Access Compliance Report

Public Rights-of-Way

(Pedestrian Signals)

Intersection ID: N/A	Main Street:	Cross Street: N/A	Location: N/A
ADA ID: 2D306F0665A6	Signal Type: Two Push Buttons-Non APS	Overall Compliance: No	Severity Score: BTN 1:N/A BTN 2: N/A No BTN: N/A
Codes/Mitigation Info/Possible Solution		Field Measurements/Component Compliance

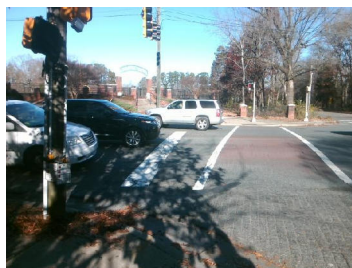
PROW/ADA: R404.2, R406.2, TMUTCD 4e.08

Possible Solutions: Provide Push Button Extension. Remove and Replace Clear Space. Replace Signal Push Button With APS Button on New Post. Remove & Relocate Sign.
